FIRE SAFETY INSPECTION REPORT

PACIFIC CASUALS LTD.

ACCORD ID: 23763

Date: 05 August, 2019

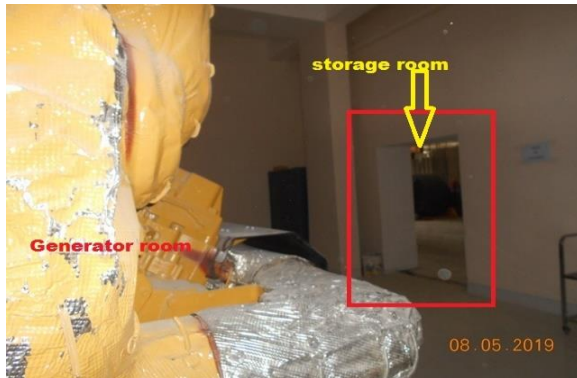
SI No.	Category	Findings	Required Action	Remediation Time Frame
F-1	Fire Rated Construction	Exit stairs are not separated from work areas & other spaces by fire-rated construction due to unprotected openings and penetrations. Location: basement & stair-4 on 1st & 2nd floors.	Provide minimum 1.5-hr fire rated doors and seal all unprotected openings to separate the exit stairs from work areas and other building spaces on all floor levels. Ensure that the fire rated doors are self-closing and positive latching and that they are provided with fire exit (panic) hardware where serving production floors. If fire rated doors are required to be held open for functional reasons, provide automatic closing devices tied to the fire alarm system. Once fire doors are installed, every door in a stair enclosure serving more than 5 stories shall be provided with re-entry unless it meets ACCORD standard 6.8.3.1	Within 6 months

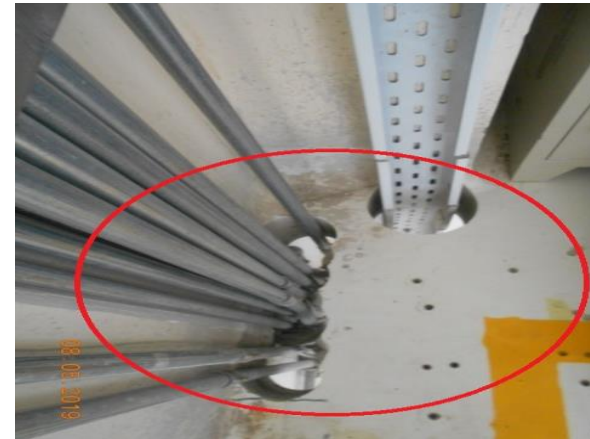
F-5	Fire Rated Construction	Unsealed penetrations and openings are located in the fire rated floor/ceiling assemblies. Location: Electrical & mechanical shafts.	Seal all penetrations and openings in floors/ceiling assemblies to maintain the fire separation.	Within 3 months
-----	-------------------------	--	--	-----------------
